## Ford and International 6.9 Diesel Engines—Mandatory Spacer

Ford & International 6.9 Liter Diesel engines CARDONE Part 59-8304 & 59-8305

### WATER PUMP MOUNTING BOLT LENGTHS & LOCATIONS

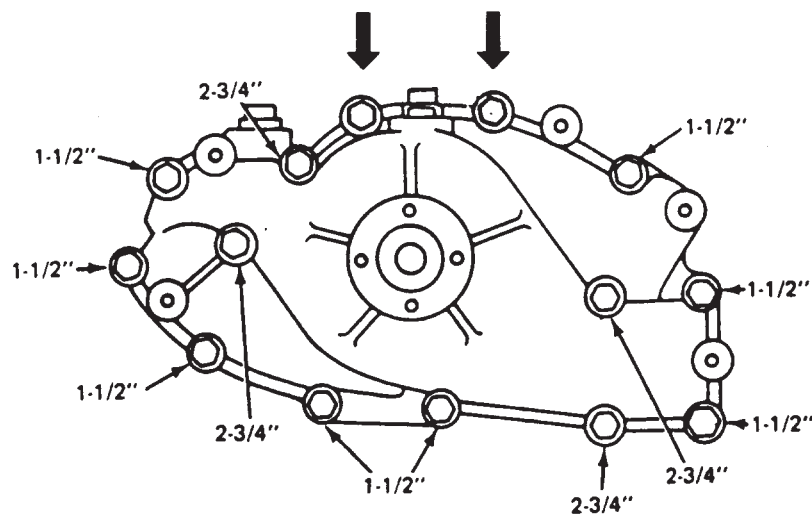
If the mounting flange on the original pump is 1-1/16" thick at the top two mounting holes and if the replacement unit is 13/16" thick, you must use two 1/8" spacers or 1-1/4" bolts.

IF THIS IS NOT DONE, INJECTOR PUMP FAILURE WILL OCCUR AND VOID THE WATER PUMP WARRANTY.
